NSW Independent  
Planning  
Commission

Pitt Street South  
OSD

INTERNAL AMENITY  
SUBMISSION

18 March 2021  
Final

# PREVIOUS

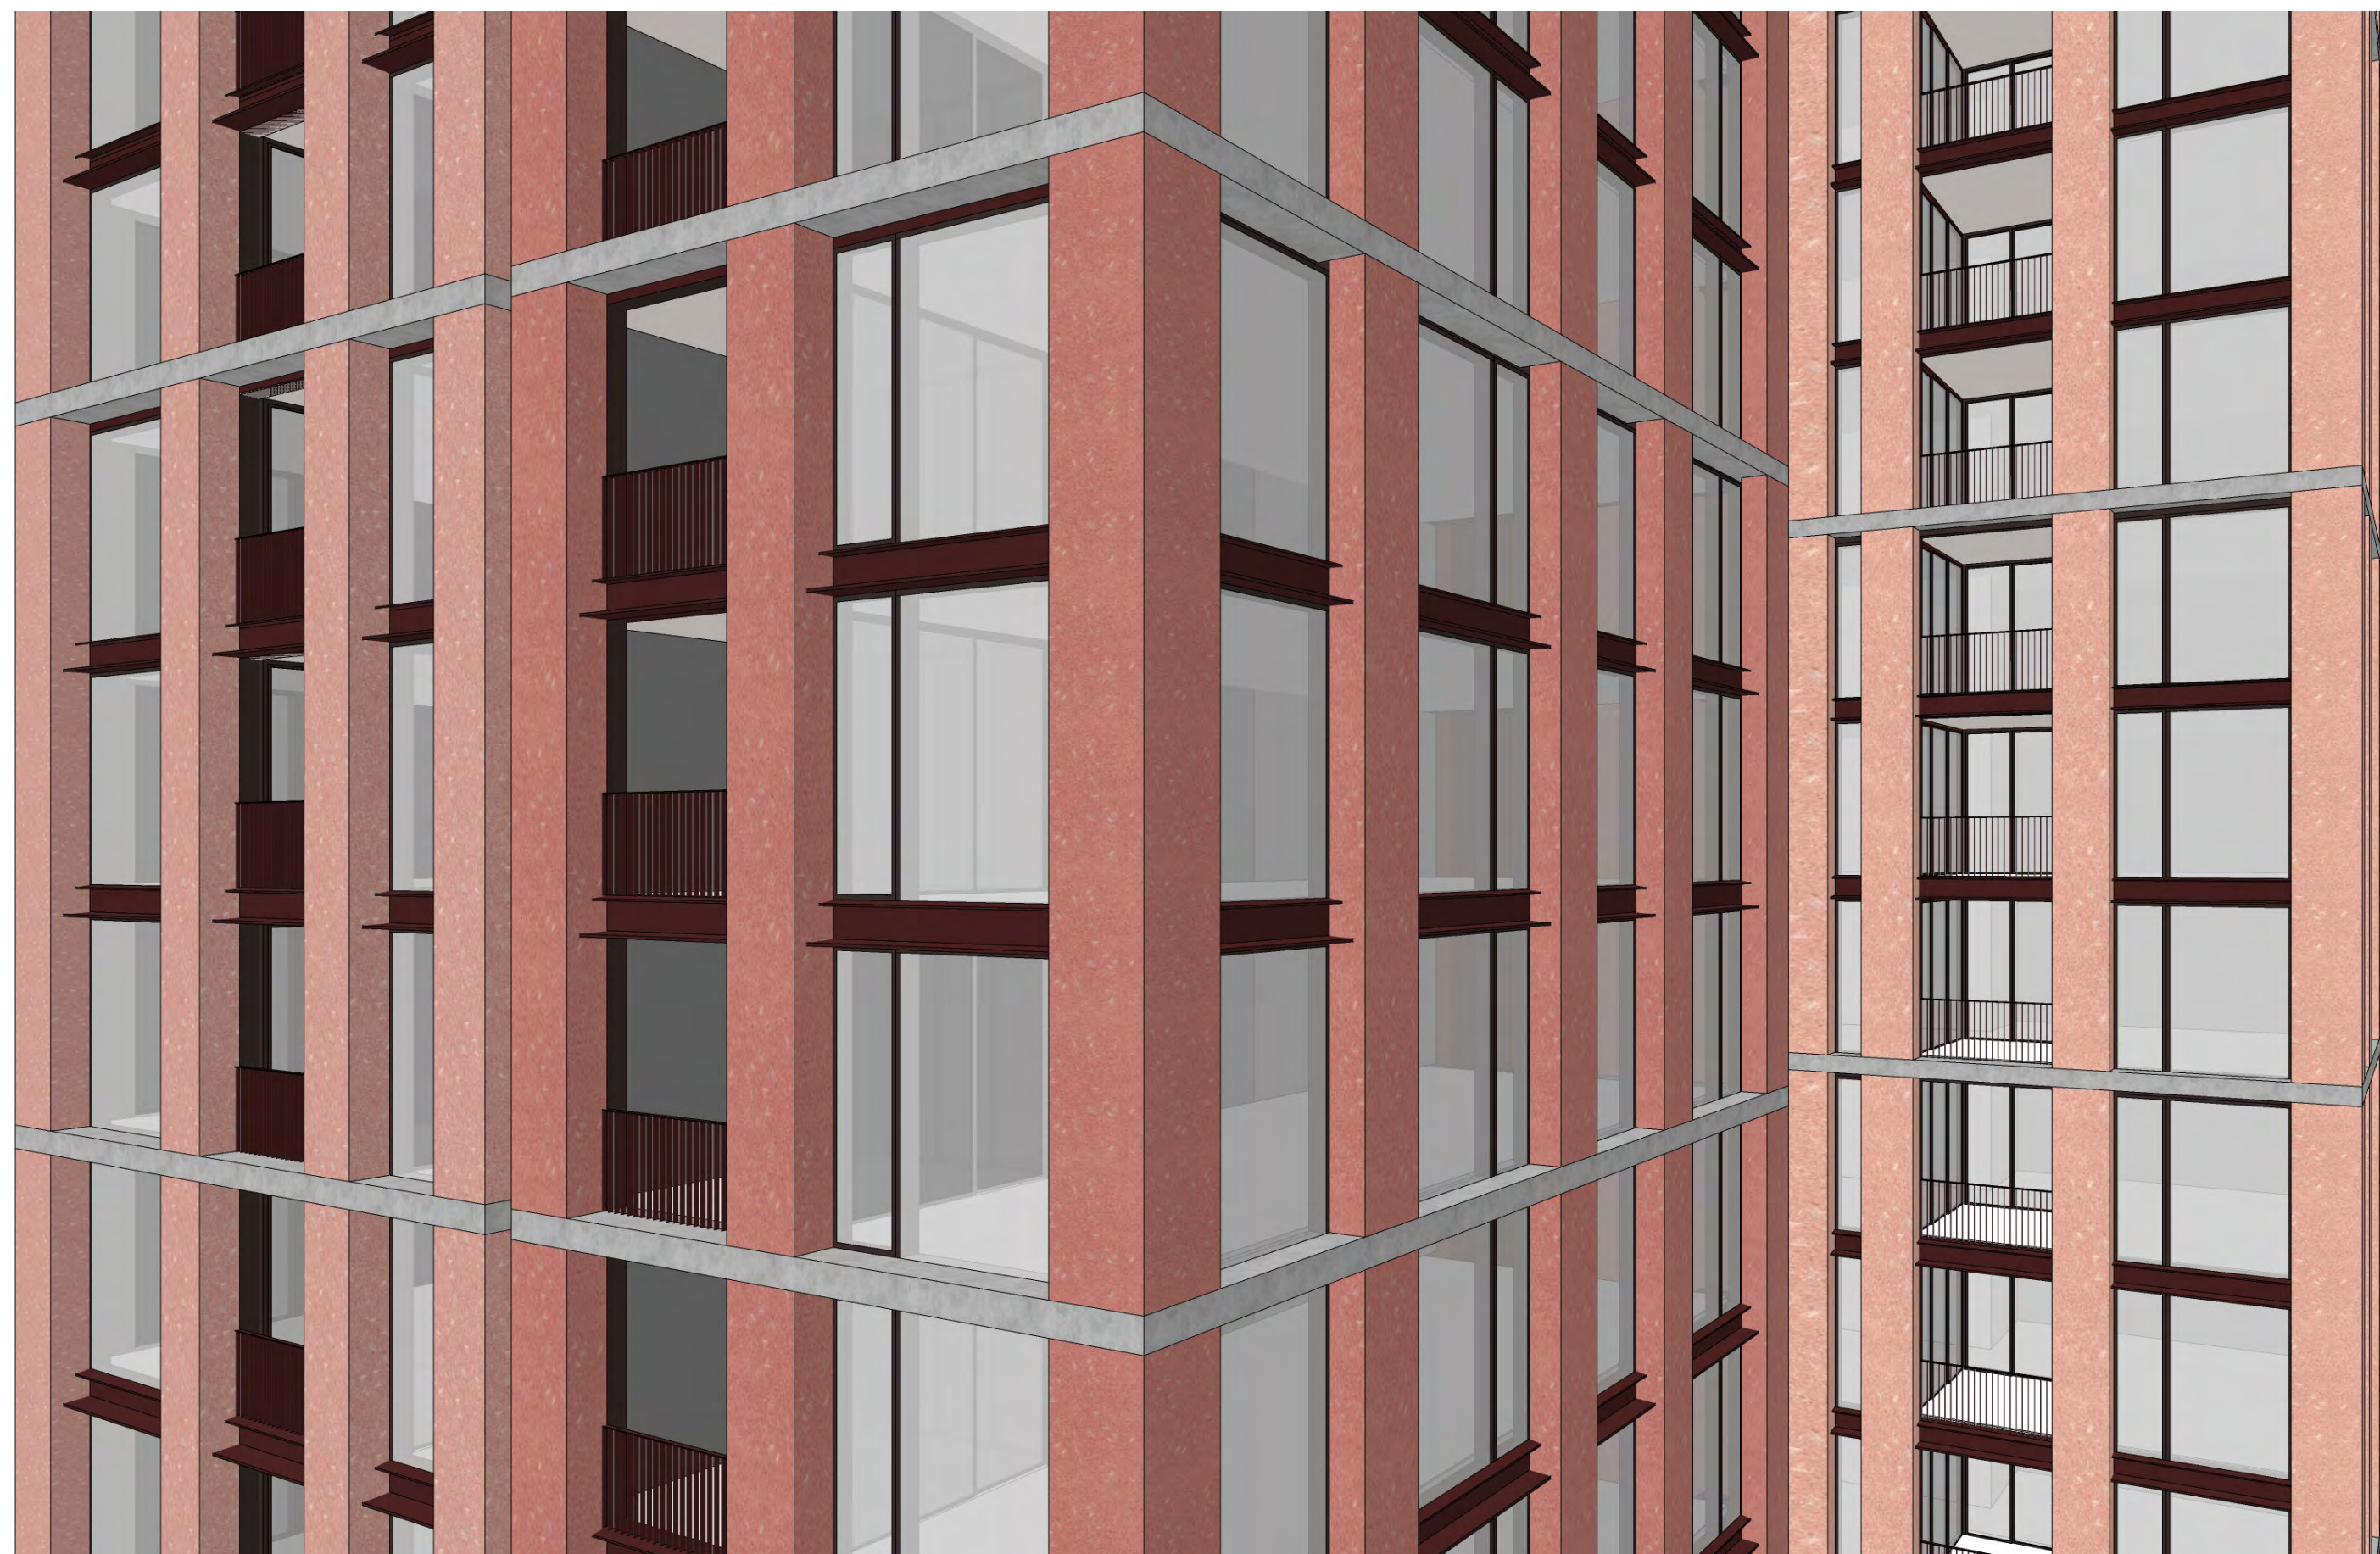
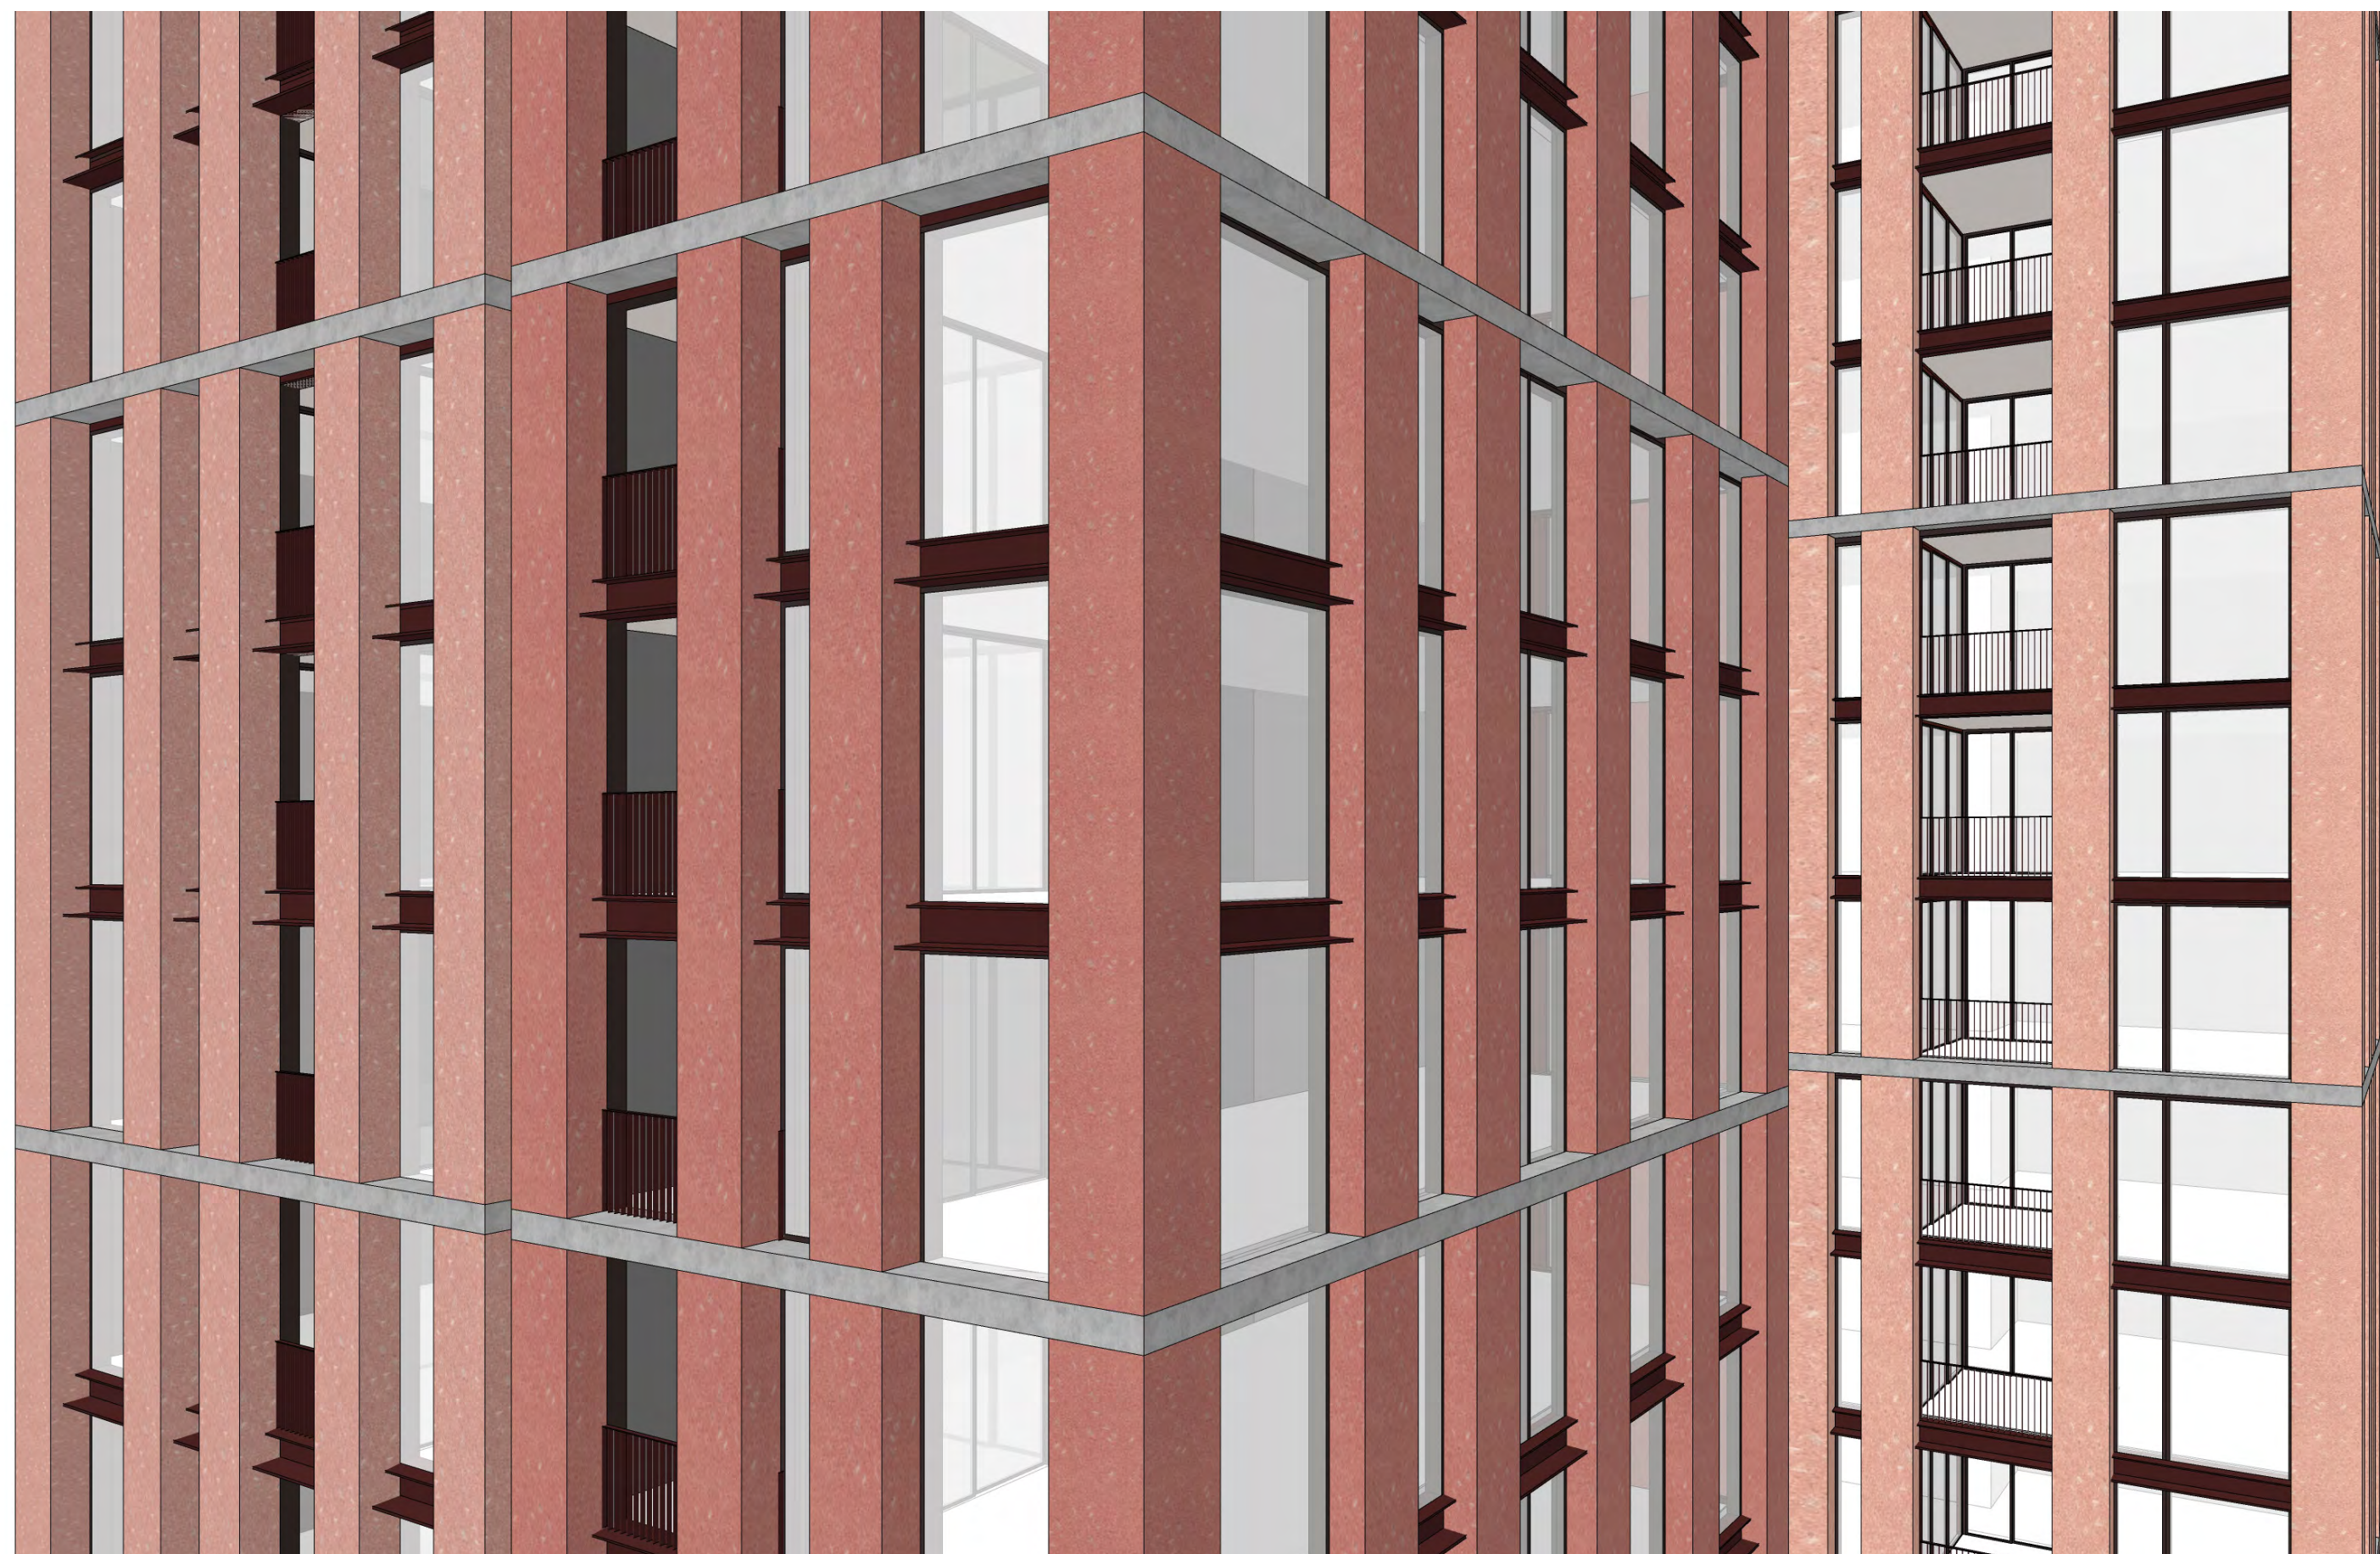
The reduction in columns made to the OSD South façade, presented in DRP 12 and 13, has a significant impact on the overall appearance and visual quality of the building and is not supported by the Panel. Whilst the Panel supports the greater level of consideration that has been given to the rationalisation of window/solid to internal planning, it recommends reviewing the original density and syncopated rhythm of the SSDA proposal, to recapture this design quality.

*One vertical added to living rooms on north east and west facades -  
logic: each face of a volume has one ‘point of compression’*

/39 GRC elements  
/900mm wide  
/400mm deep  
/50mm gap to facade

/44 GRC elements  
/900mm wide  
/400mm deep  
/50mm gap to facade

/39 GRC elements  
/900mm wide  
/400mm deep  
/50mm gap to facade

/44 GRC elements  
/900mm wide  
/400mm deep  
/50mm gap to facade
